# Determination 2025/049

## The compliance of a replacement cladding system on a dwelling with clauses B2 and E2 of the Building Code

16A Marellen Drive, Red Beach, Auckland<sup>1</sup>

Plan 1: Floor plan with locations of details (not to scale)

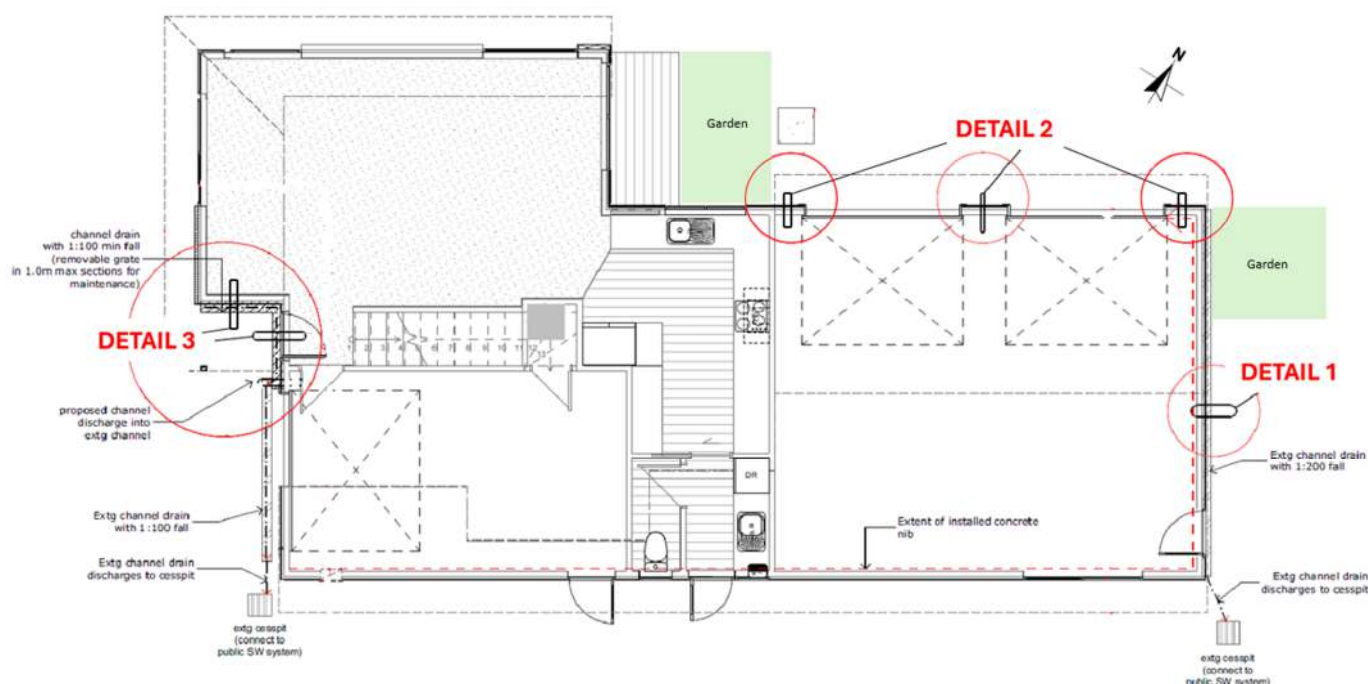
- 2.3. This determination is concerned with three details, with the issue in dispute being the termination of the cladding relative to the finished ground and channel drains below. Details 1 and 2 have been constructed on two elevations of the rear garage. Detail 3 is proposed for the external walls adjacent to the front entrance, above a channel drain that is proposed to be replaced. See Plan 1.

**Figure 1: Detail 1 – as-built cladding detail (not to scale) and photo along northeast elevation of rear garage**

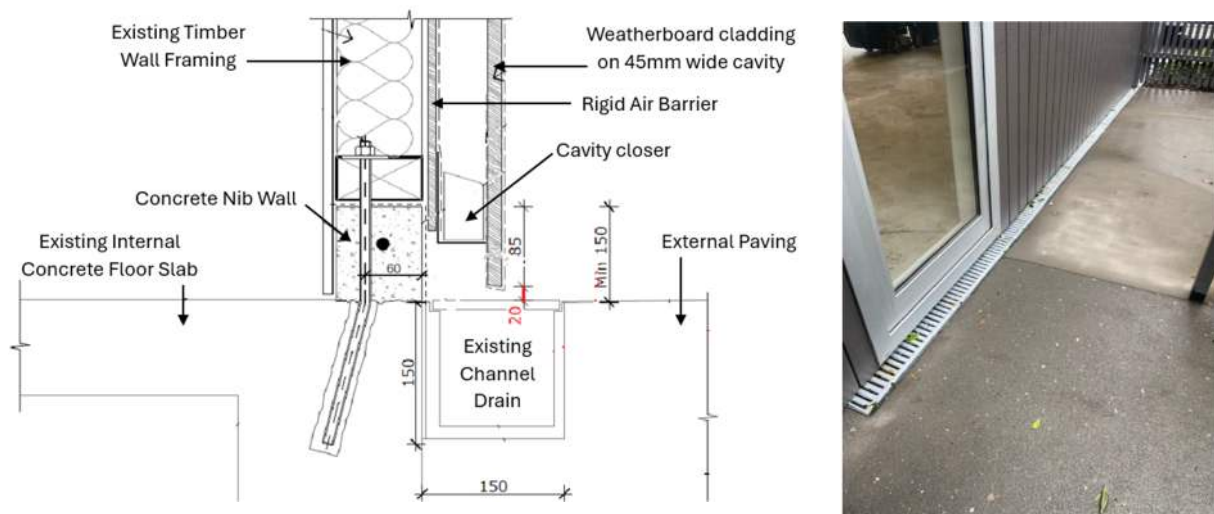
- 2.4. Figure 1 shows the as-built cladding detail for the northeast elevation of the rear garage (Detail 1). It comprises a concrete nib installed to raise the height of the timber bottom plate of the external wall to a minimum of 150mm above the finished ground level. Externally, there is an existing channel drain at the base of this nib and below the cladding system, covered with a grate. The weatherboards extend down past the top of the concrete nib, with a 20mm clearance between the

bottom of the cladding and the top of the channel drain grate. There are no eaves above the cladding in this location.

- 4.34. Detail 1 describes how the cladding system has been constructed on the northeast elevation of the garage, which has no overhanging eaves and is above an existing channel drain. The drain is 150mm wide and 150mm deep, with a grate on top of it. The adjacent ground is primarily paved, although there is also a short section of garden next to the northern end of the drain and beneath the cladding. The bottom of the cladding terminates 20mm above the grate of the channel drain.
- 4.35. In their submissions, the owner noted the existing garage is not a 'habitable space'<sup>15</sup> and made the following comments about Detail 1.
- 4.35.1. The new nib wall beneath the bottom plate maintains the 150mm clearance to paved ground, as specified in E2/AS1, without the channel drain and "a clearance of more than 150mm is achieved from the base of the channel [drain]".

- 4.35.2. “The open channel [drain] grate directly below the cladding ensures that water will not be ponding directly below the cladding”. In the owner’s view, this is similar in detailing to situations where cladding terminates above a deck (timber or membrane) or a membrane roof.

- 4.37. However, I do not agree with the owner’s assessment of how the channel drain and cladding system will function in this location.
- 4.38. The area surrounding the channel drain is primarily paved ground which, in the photos provided, does not show any fall away from the garage. The channel drain will therefore be collecting and disposing of water from the paved surface as well as from the cladding.<sup>16</sup> In this location the external wall is also exposed with no eaves.

- 4.39. The channel drain is shown to have a fall of 1:200, which provides a shallower fall and over a significantly longer length (6m) than provided for in the Acceptable Solution (where a maximum length of 3.7m is specified). The length and fall in this location increase the risk of ponding within the drain.

- 4.40. In my opinion, these aspects of the construction of Detail 1 means there will be increased moisture levels within the channel and higher levels of humidity around the base of the cladding system. This is due to the channel collecting moisture from both the cladding and paved surface, as the channel drain is the primary surface water disposal system for the surrounding ground, coupled with the length and fall of the drain.

- 4.41. The increased moisture levels are also likely to be exacerbated by additional humidity from the adjacent concrete paved ground. Also, although the drainage channel grate can be removed for maintenance purposes, as is apparent in the evidence provided, the limited clearance between the grate and the cladding leads to a build-up of debris between the channel drain grate, which requires increased maintenance (ie monitoring and removal) to prevent further reduction in ventilation and increased humidity.

- 4.42. I acknowledge that the orientation, treatment levels, and the nib wall will all contribute to the performance of the cladding system and durability of the building elements. However, due to a combination of the features in this location, I consider that there is a higher likelihood of elevated moisture in the cladding system effecting its drying capacity along this elevation, with a resulting increase in the risk of condensation and accumulation of moisture. The owners have not provided any

- 4.43. I consider the lack of information about how the cladding system is to manage the levels of moisture within the cavity that would result in moisture being accumulated or transferred and causing condensation, fungal growth or the degradation of building elements means compliance with clauses E2.3.2 and E2.3.5 has not been demonstrated for the constructed section of the cladding system along the northeast elevation of the rear garage described in Detail 1.

- compliance with clauses E2.3.2 and E2.3.5 has not been demonstrated for the as-built section of the cladding system along the northeast elevation of the rear garage described in Detail 1
- the as-built cladding system terminating above paved ground adjacent to the rear garage doors on the northeast elevation described in Detail 2 complies with clauses E2 and B2
- the proposed Detail 3 for the cladding system terminating above a channel drain at the front entrance of the dwelling complies with clauses E2 and B2.

**Figure 2: Detail 2 – as-built cladding detail (not to scale) and photos of northwest elevation of rear garage adjacent to doors**

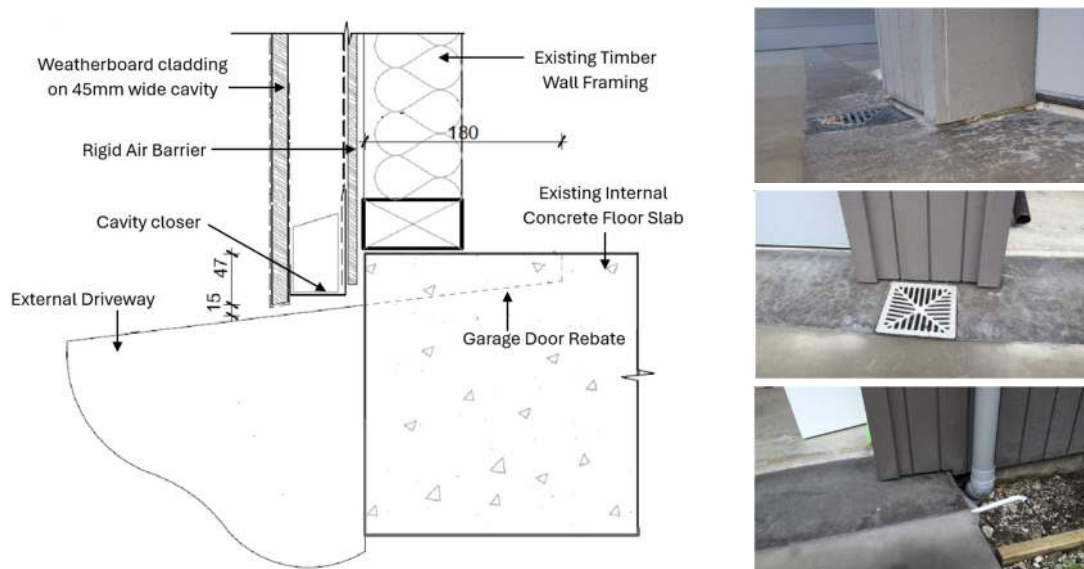
- 2.5. Figure 2 shows the as-built detail to the northwest elevation of the rear garage (Detail 2). The cladding system in this area is adjacent to the rear garage doors, covers a maximum of 700mm lengths in three locations, is installed over a cavity, and extends down to within 15mm of the concrete paved driveway below. In this location, the bottom of the existing external wall framing is within 60mm of paved ground and there are 600mm eaves overhanging the external walls.

- 4.44. Cladding Detail 2 applies to the construction of three sections of external cladding between 500 and 700mm wide at the sides and between the rear garage doors on the northwest elevation.<sup>17</sup>

- 4.46. Where Detail 2 differs is in respect of its location and where the base of the cladding terminates, notably the fall on the driveway and the 600mm wide eaves of the garage above.

- 4.47. In their submissions, the owner noted the existing garage is not a habitable space and made the following comments about Detail 2:
- 4.47.1. The length of cladding with reduced clearance to the paved ground is short.

- 4.47.2. "It is impractical to achieve the [E2/AS1] threshold [of 100mm in this location] ... when the existing single garage doors are closely spaced together".

- 4.47.3. The eaves above the cladding, being 600mm deep, provide cover for the area.
- 4.47.4. There is a "good fall away from the building in the existing concrete drive[way]" and the storm water sump and garden adjacent to the paved area ensure there is "no ponding adjacent to the cladding".

- 4.48. I agree that the slope of the driveway in front of the cladding and garage doors will move surface water away from the base of the cladding. This will lessen humidity by reducing the ability of water to pond below the cladding. Drainage is also enhanced by the presence of the two stormwater sumps in front of (but not directly below)

- 4.49. The 600mm eaves above the cladding and the single storey height of the garage provide deflection and cover for the cladding, meaning less surface water in this location when compared with Detail 1 along the northeast elevation.

- 4.50. Given the factors in this location, in particular those that support the cladding's deflection and drainage away from the cladding system, I consider that the risk of moisture transfer or accumulation in the cavity as condensation, and of this leading to undue dampness and fungal growth is low. I therefore consider that the construction of the cladding system on the northwest elevation of the rear garage described in Detail 2 will achieve compliance with clauses E2.3.2, E2.3.5.

**Figure 3: Detail 3 – proposed cladding and channel drain detail (not to scale) and photos of front entrance porch and existing drain**

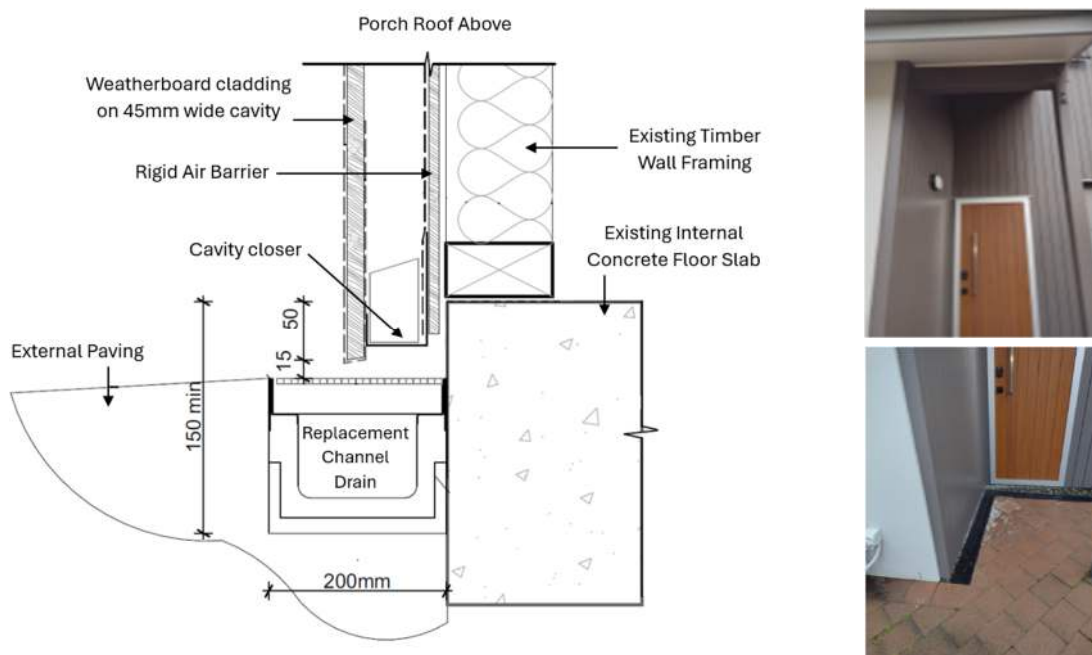
- 2.6. Figure 3 shows the proposed cladding detail for the southwest elevation of the dwelling adjacent to the front entrance (Detail 3). The cladding system is to be installed on two short wall elevations, with a new channel drain and grate (to replace an existing drain) connecting into an existing drain to dispose of any surface water collected. The cladding system is to extend down to within 15mm of the channel drain grate. In this area, a porch roof extends between 1.1m to 1.3m beyond the external walls and is open on two sides. Existing pavers fall away from the external walls.

- 4.53. Cladding Detail 3 proposes the construction of the cladding system on the external walls of the southwest side of the dwelling, adjacent to the front entrance, and replacement of a channel drain below the cladding.<sup>18</sup>
- 4.54. The channel drain will be 200mm wide and 150mm deep, replacing the existing smaller one (150mm wide by 150mm deep). The drain consists of two sections at right angles to each other with falls of 1:100. The drain will run immediately below the cladding, with the clearance between the bottom of the cladding and the grate on top of the channel drain being 15mm. It is then proposed to connect to another existing channel drain that runs along the opening of the front garage, with the

4.55.1. The location of the cladding and channel drain is covered and protected by the entry porch above “ensuring that the channel drain will largely remain dry, only becoming temporarily wet in wind driven rain events”.

4.55.2. The distance between the bottom of the channel drain and the timber bottom plate of the wall framing will be 150mm, which meets the minimum clearance requirement shown in Figure 17B of E2/AS1 (which concerns channel drains at level thresholds) and will be greater than the clearance currently being achieved in this location.

4.55.3. The channel drain will only run beneath the proposed cladding for a maximum length of 1400mm.

4.56. I agree with the owner that the location and cover to the area in which Detail 3 is located are significant factors in considering compliance of the cladding system. The areas of cladding are largely sheltered by the entry porch overhang above, which means there is minimal risk of significant amounts of water contacting the cladding system. In turn, the risk of moisture entering the cladding cavity through gaps and cracks beyond what is able to be handled by drainage and drying is low.

4.57. The design of the channel drain is proposed to have a smaller capacity and to meet the fall of 1:100 set out in E2/AS1. The drain would not collect significant amounts of water in this location where the cladding and adjacent paving are sheltered, and I consider the risk of increased humidity that could affect the drying performance of the cavity is low.

4.58. While there is a limited area of cladding (approximately 500mm wide) to one side of the front door that is not covered by the porch roof, I consider the size and location of this area make it unlikely that the proposed construction will lead to condensation in the cavity and in turn, fungal growth or undue dampness or damage.

4.59. As with Detail 2, the existing timber bottom plate within the wall framing is in close proximity to the outside ground, being 75mm from the top of the channel grate in Detail 3. However, given the location of the external walls protected by the porch above and my conclusions that the channel drain is unlikely to collect or hold significant amounts of water, the risk of moisture being present in the cladding system cavity to a level which may cause fungal growth and undue dampness in this area is low and I consider the timber wall framing is protected from being exposed to moisture of a level that could cause undue dampness or damage.

4.60. I therefore consider that the proposed construction of the cladding system on the southwest elevation around the front entrance described in Detail 3 will comply with clauses E2.3.2, E2.3.3, and E2.3.5 as an alternative solution.
